Review and Rebuttal of SNWA Submissions In Support of Applications for Groundwater From Cave, Dry Lake and Delamar Valley

**For Submission to the Nevada State Engineer
For the Cave Valley, Dry Lake, and Delamar Valleys Hearings**

Tom Myers, Ph.D.
Hydrologic Consultant
Reno, NV

12/19/2007

Figure 1: Snapshot of Figure 4-2 (SNWA 2007, Part A) comparing PRISM precipitation estimates with weather station data.

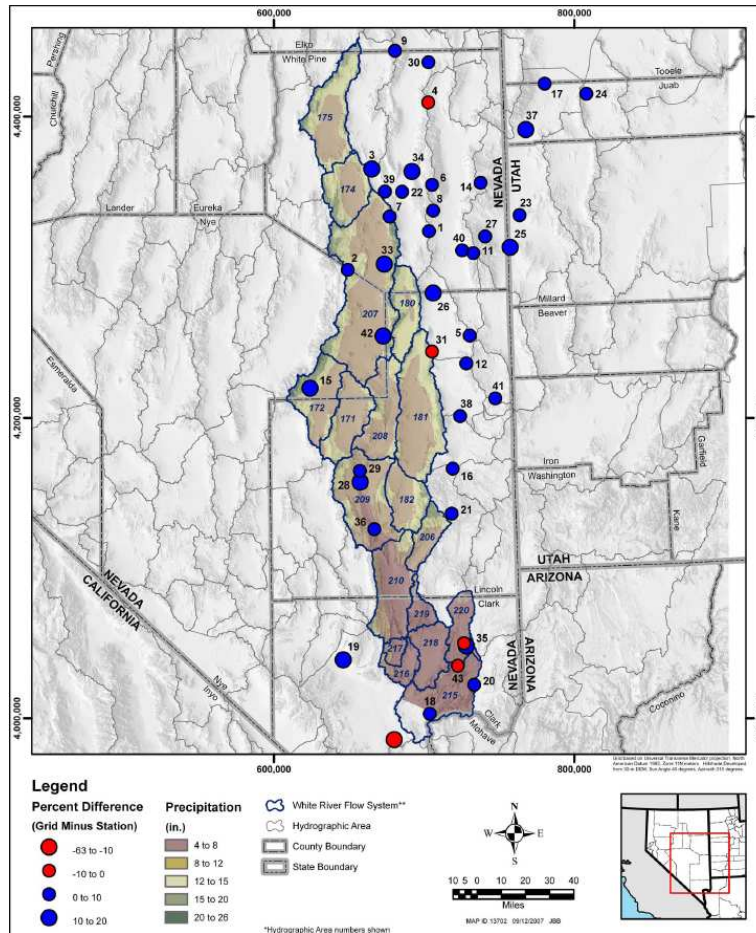
SNWA used PRISM for precipitation estimates. Myers (2007) reported that Jeton et al (2005) found that PRISM overestimated precipitation at many points in Nevada. However, SNWA asserted that PRISM data sets are “recognized world-wide as the highest-quality spatial climate datasets currently available” (SNWA 2007, Part A, page 4-2). This assertion is unreferenced and, based on my experience, completely unfounded. Apparently, SNWA (2007) used a more recent PRISM estimate, but it is unknown how this estimate compares with the estimate used by Jeton et al (2005). SNWA presented an estimate, with little discussion, of the percent difference between precipitation stations near the WRFS and PRISM precipitation stations. It showed that PRISM overestimated annual precipitation at 38 of 43 stations near the WRFS (Figure 1). This demonstrates exceptional inaccuracy on which SNWA certainly should not base its water balance model.

The only location where stations approximately balance each other out is in the south end near the Colorado River. The one station that PRISM underestimates average annual precipitation near Dry Lake Valley does not cancel the nine stations at the latitude of Dry Lake or Delamar Valleys which are overestimated. SNWA's comparison of PRISM with actual weather station data show that PRISM likely overestimates precipitation by up to ten percent, as indicated by Myers (2007).

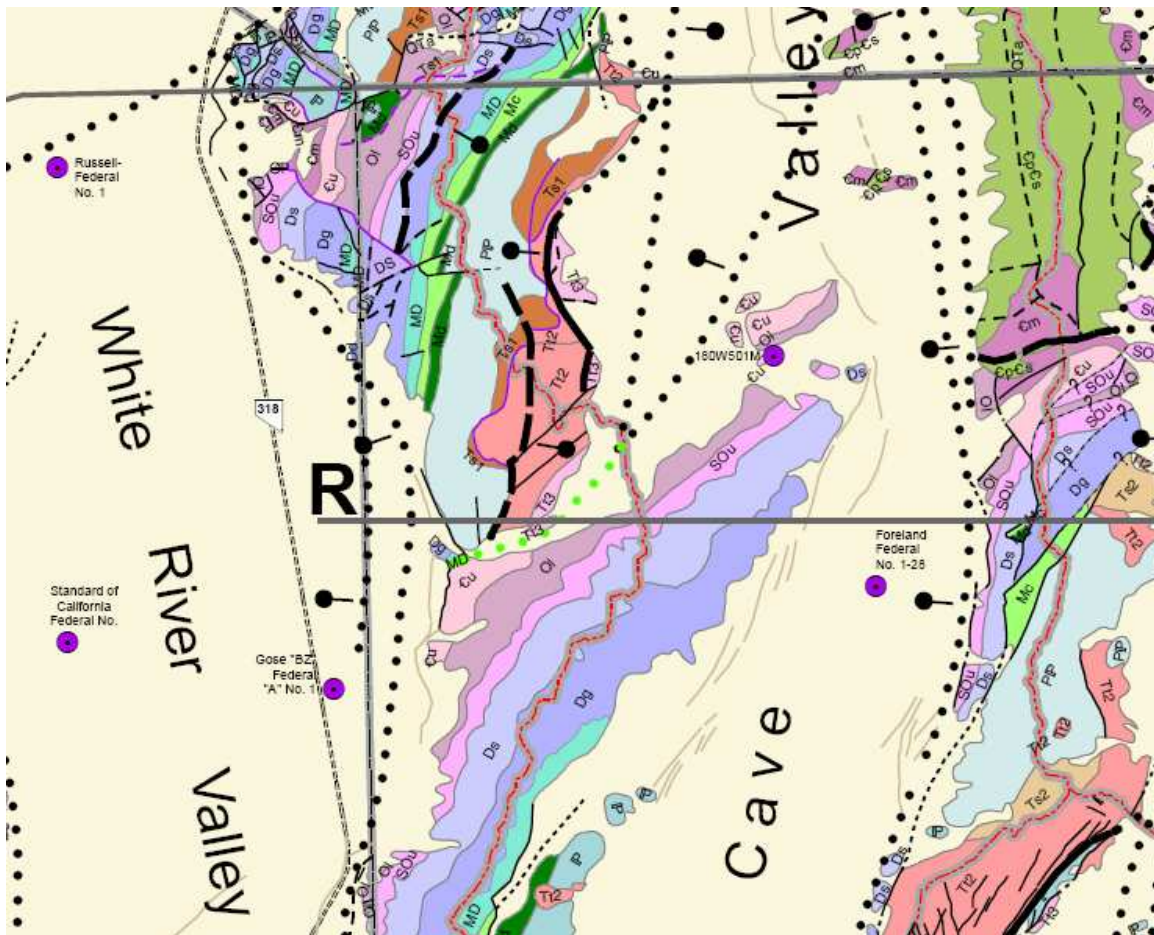
The north half of Cave Valley has more recharge than the south half as shown in SNWA Figure 5-2 (SNWA 2007, Part 1). The block that separates the north from the south, and causes the substantial drop in the valley floor, contains Mississippian Chainman Shale (SNWA 2007, Part 1, page 2-1) which is an impedance to flow (Figure 3 and Myers (2007, Figure 2)). The 1000-foot topographic north-south drop through the profile of Cave Valley is testament to the block's resilience. The flow barrier across the center of the valley would prevent most of the flow originating in the north half from reaching the south half. The only discharge point other than the GW ET discharge noted by Myers (2007) and SNWA (2007) must be Shingle Pass (Figures 3 and 4).

Figure 5: Snapshot of section of SNWA (2007) Plate 1 showing the south end of Delamar and Pahranaagat Valleys and the north end of Coyote Spring Valley.

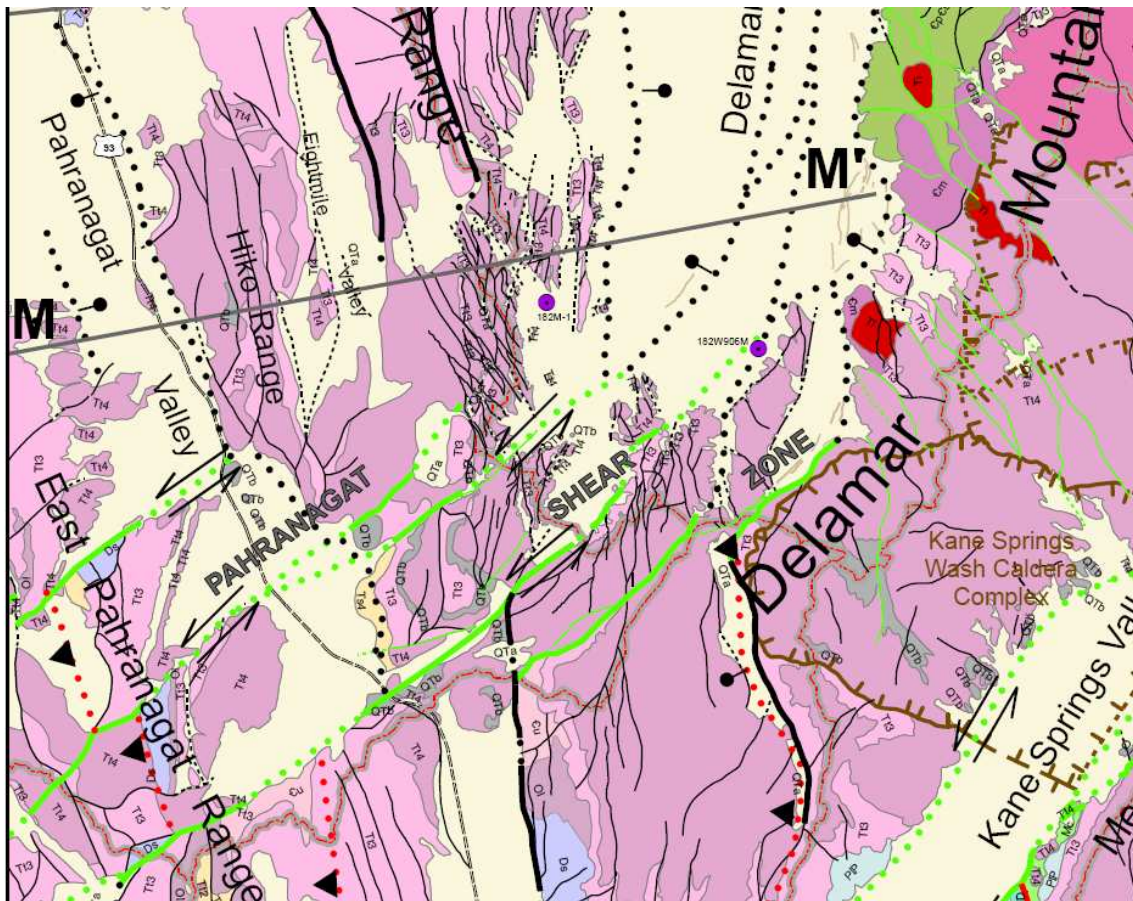
The elevation in the southern, lower elevation, part of Delamar Valley is about 4500 ft msl while in Pahrnagat Valley the elevation at the south end of the valley is about 3300 ft msl. Depths to water in Delamar Valley, at least for the regional water table, are large – as much as 800 feet (Eakin 1963). The connection between the areas would be along the faults of the Pahrnagat Shear Zone (Figure 5). Surface elevations in Coyote Spring Valley range from 3200 ft msl at the north near the boundary with Pahrnagat Valley to 2600 ft msl near the intersection with Kane Springs Valley. The depth to water in Coyote Spring Valley would probably cause there to be a steeper gradient between Delamar and Coyote Spring Valley. The connection would be across the Pahrnagat Shear Zone (Figure 5).

The Pahranaagat shear zone bounds the south end of both Delamar and Pahranaagat Valleys. Several faults trending northeast along the shear zone, shown in green in Figure 5, borrowed from SNWA (2007), apparently connect the valleys. The Pahranaagat Shear Zone does not include the range front faults that SNWA claims would prevent the flow to the south end of Pahranaagat Valley (Figure 5). In order for flow to occur from Delamar to Coyote Spring Valley, it would need to cross transversely the faults in the shear zone.

It is far more likely that the faults in the southwest Delamar Valley are a conduit for groundwater flow from Delamar to Pahranaagat Valley.

Figure 6: Snapshot of SNWA (2007, Part A) Figure D.3-2.

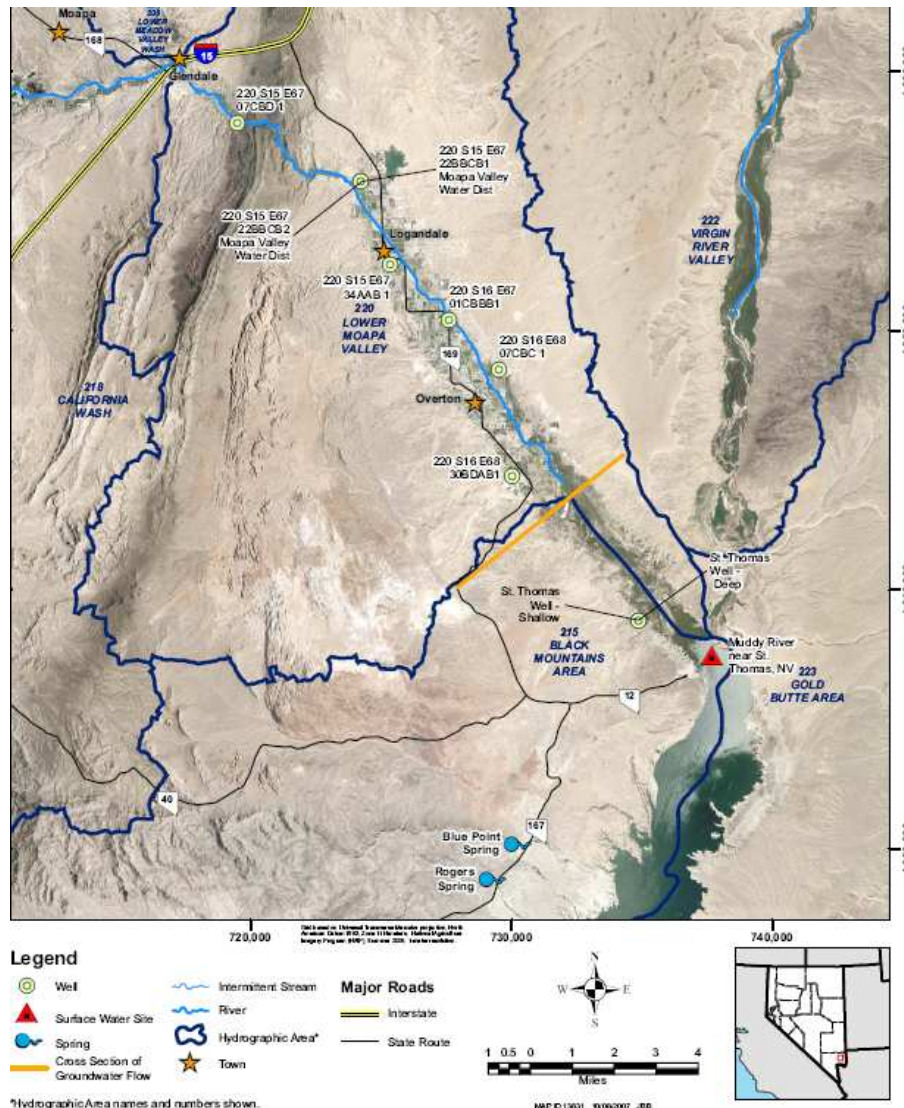
First, some of the flow must be double-counted. Based on measured flow at the St. Thomas gage between 1913 and 1916, SNWA estimated “[f]or this analysis, it is estimated that about half of the flow was groundwater discharge, or 7,000 afy” (SNWA 2007, Part A, page D-21). The total flow was the mean annual flow for 1914 (*Id.*), the only year with a complete record. This gaging station is less than five miles directly downstream on the Muddy River from the cross-section used to calculate groundwater flow along the Muddy River in the Lower Moapa Valley (Figure 6). The 7000 af/y must be part of the 16,000 af/y flow estimated at the cross-section.

Figure 7: Scan of portion of geologic map from Page et al (2005).

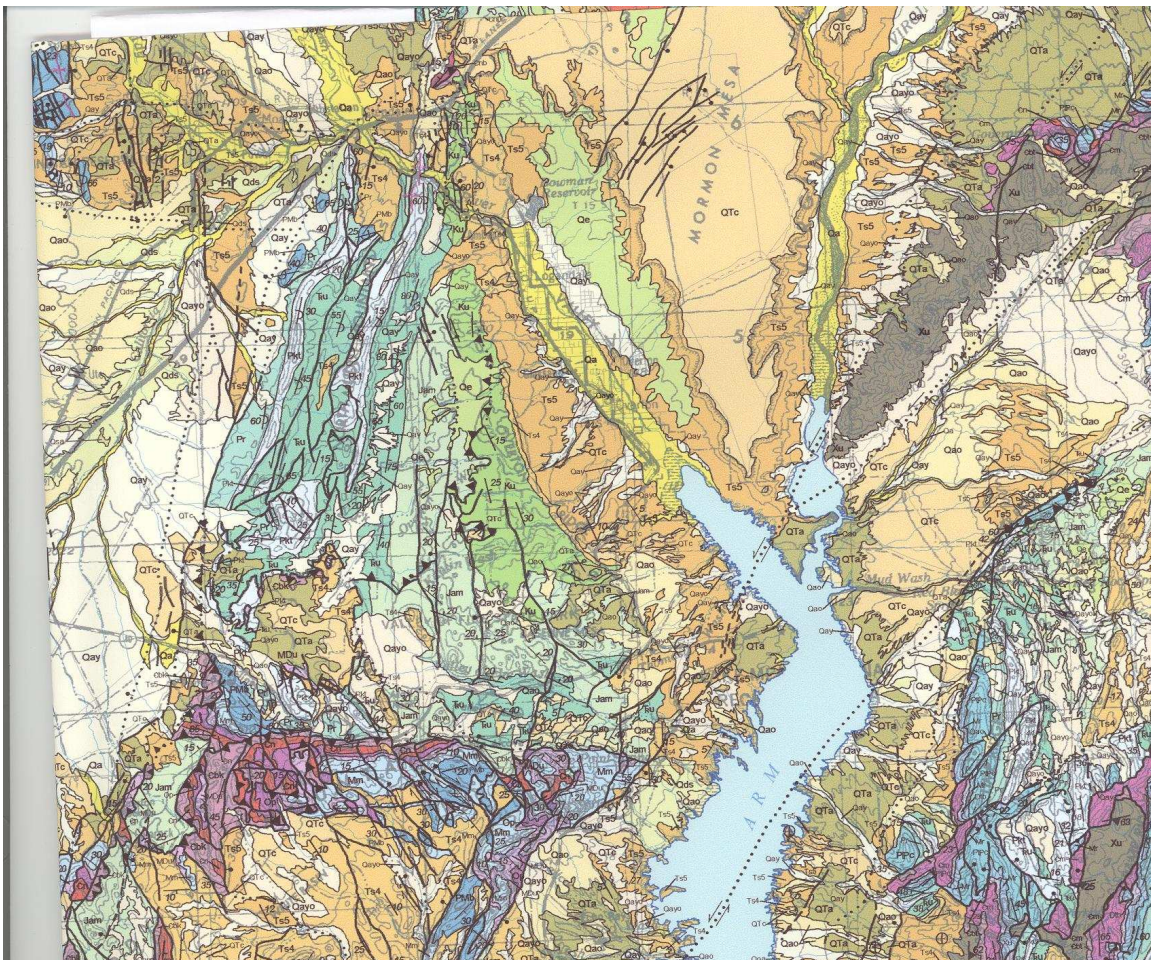
Third, the cross-section used for the 16,000 af/y component of the estimate is 26,500 feet wide. Using a transmissivity of 17,000 ft²/d (SNWA 2007, Part A, page D-22) and an average gradient based on various wells next to the river of 0.00432 (SNWA 2007, Part A, page D-23), the flow estimate was 16,000 af/y (*Id.*). This estimate is too high because the cross-section is much longer than would be representative of the actual hydrologic properties and the transmissivity is too high. Considering the geologic map in Figure 7, the cross-section would span the Ts5 and Qa geologic formation just upstream from where the Muddy River enters Lake Mead. Because the wells were near the river, it

The description by Page et al (2005) does not suggest a highly conductive zone that can be treated as homogeneous across a 26,500 foot wide cross-section. And the transmissivity used for the calculation is probably much too high because it is based on very shallow wells next to the river.
